SUBMITTAL OF HANFORD FACILITY RESOURCE CONSERVATION AND RECOVERY ACT (RCRA) PERMIT MODIFICATION NOTIFICATION FORM 24590-HLW-PCN-ENV-06-009

Hanford Facility RCRA Permit Modification
Notification Form 24590-HLW-PCN-ENV-06-009

Page 2 of 2: Hanford Facility RCRA Permit, Part III, Chapter 10, and Attachment 51, Appendix 10.7
Update Engineering Specification for HLW System HDH Canister Rinse Bogie (24590-HLW-3PS-MQR0-TP002)
in Appendix 10.7 of the Dangerous Waste Permit.

HLW System HDH Canister Rinse Bogie

Appendix B Seismic Response Spectra

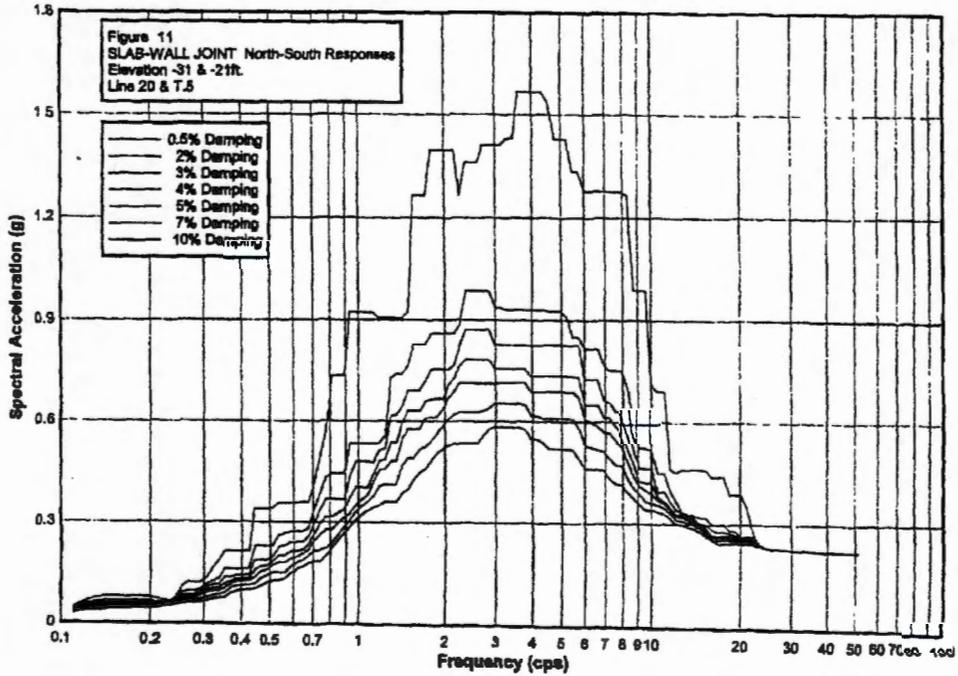
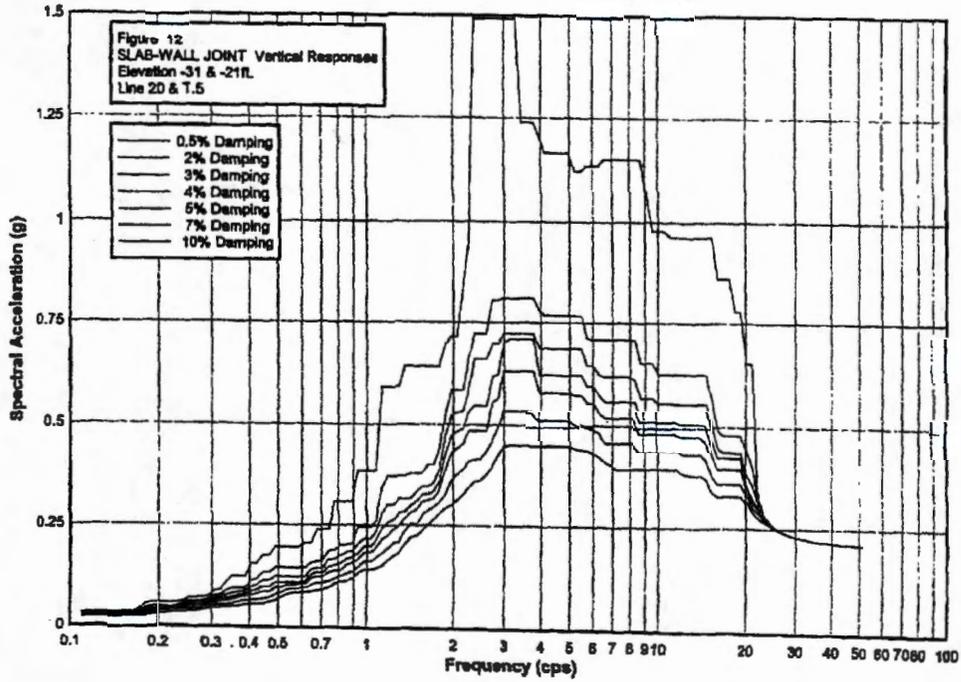
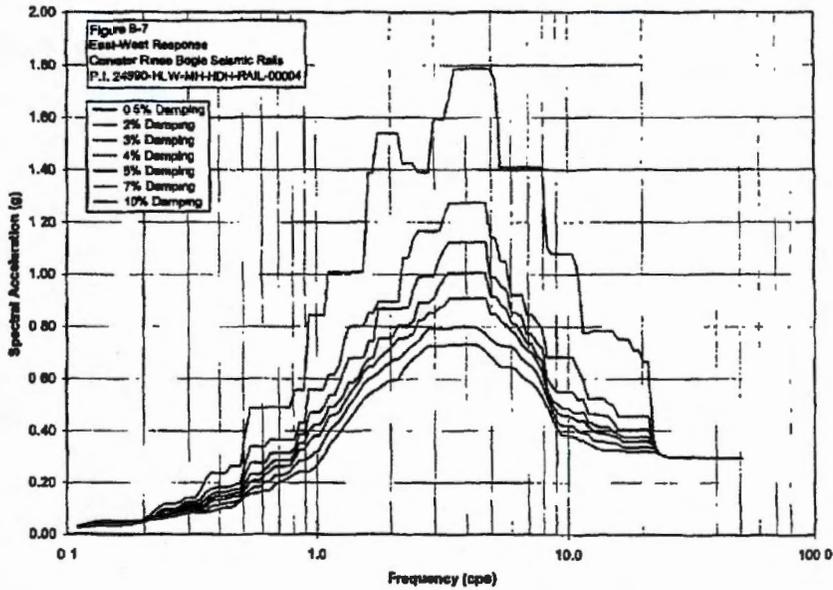
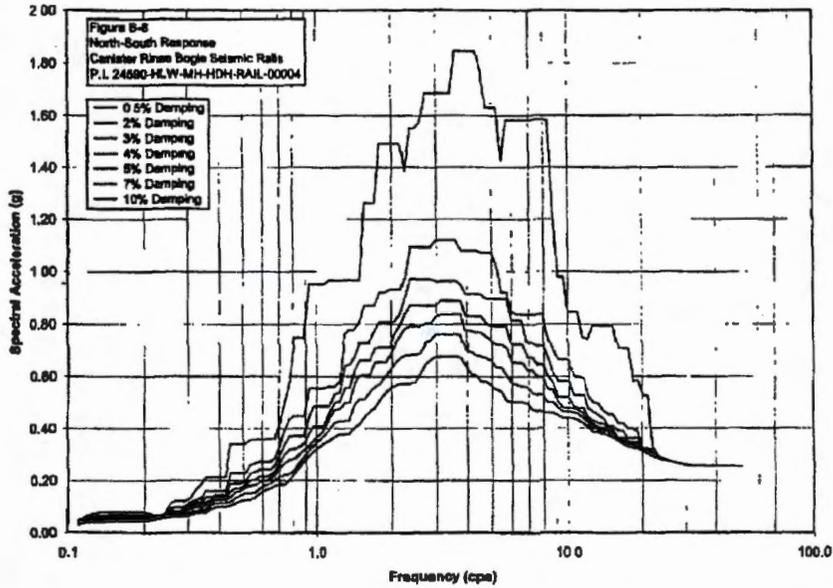
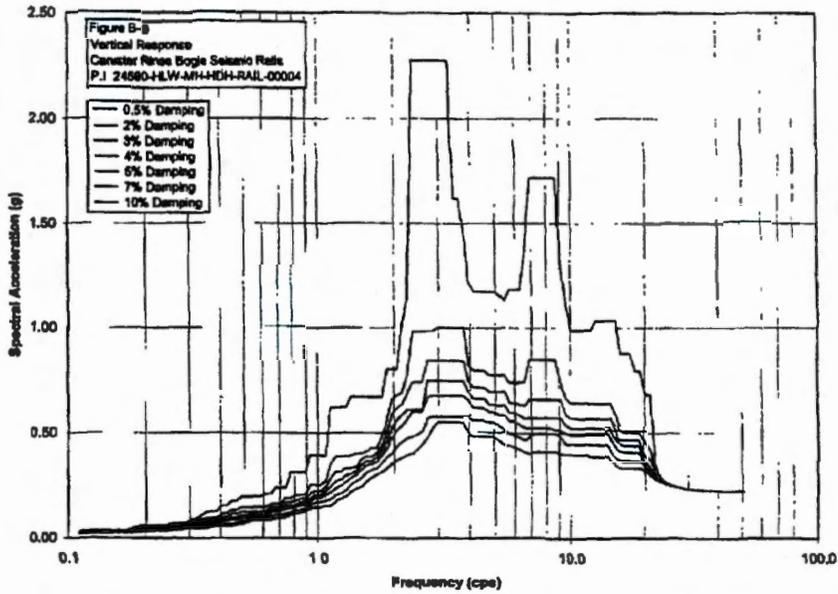
- Incorporation of in-structure response spectra in accordance with revised ground motion. (Sections 2.5.3, 2.5.4, 5.6.4.3 and Appendix B)
- Added tables for concrete placement tolerances and embedded item placement tolerances. These tables were previously identified in one of the referenced specifications (24590-WTP-3PS-D000-T0001). (Sections 5.1.3, 5.1.3.1, and 5.1.3.2)

5.6.4.3 SSCs designated SC-II, see Section 1.5.3 of this specification, the seismic loads imparted on the equipment shall be evaluated in accordance with the response spectra identified in the table below. A damping value of 7% shall be used.

Equipment	Seismic Response Spectra Reference
Canister Rinse Bogie (24590-HLW-MQ-HDH-TRLY-00003, and associated equipment)	See 24590-HLW-S0C-S15T-00009 Rev 0D Fig. 10 Seismic Response at -31 ft and -21 ft Elevation, East-West Fig. 11 Seismic Response at -31 ft and -21 ft Elevation, North-South Fig. 12 Seismic Response at -31 ft and -21 ft Elevation, Vertical
Canister Rinse Bogie Seismic Rails (24590-HLW-MH-HDH-RAIL-00004, and associated equipment)	See 24590-HLW-S0C-S15T-00039 Rev D Sheet No. B-9, Fig. B-7 Seismic Response, East-West Sheet No. B-10, Fig. B-8 Seismic Response, North-South Sheet No. B-11, Fig. B-9 Seismic Response, Vertical
